ONSITE SEWAGE DISPOSAL SYSTEM

PERMIT
MINOR REPAIR

A Repair

PROPERTY ADDRESS: 587 W. Watersville Road

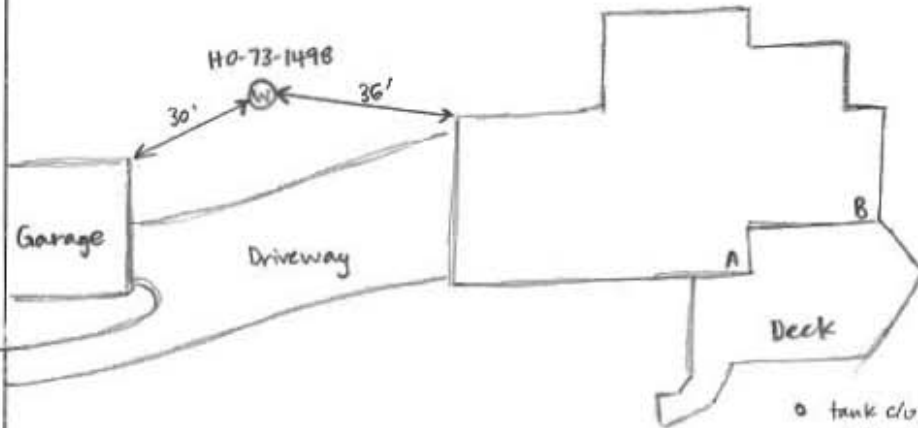
LOCATION:	
NOTES:	Tie existing trenches into septic tank and abandon dry well.

o tank c/w
 24' to A
 36' to B

3' tie-in to ex. line
 45' to A
 51' to B
 tie-in to
 ex. trenches

INSTALLATION: 7/5/18 line run from existing inlet of drywell to D-box + trenches. Drywell already filled w/ #67 stone. J+A removed lid. Line off side of D-box had no fall - J+A dug below line to create fall. No speed levelers - J+A dug below other line to create equal flow to both trenches out of D-box. Checked flow with water. Stone at trenches is dry where lines enter @ inlet depth. [Corrective action completed.] (SC)
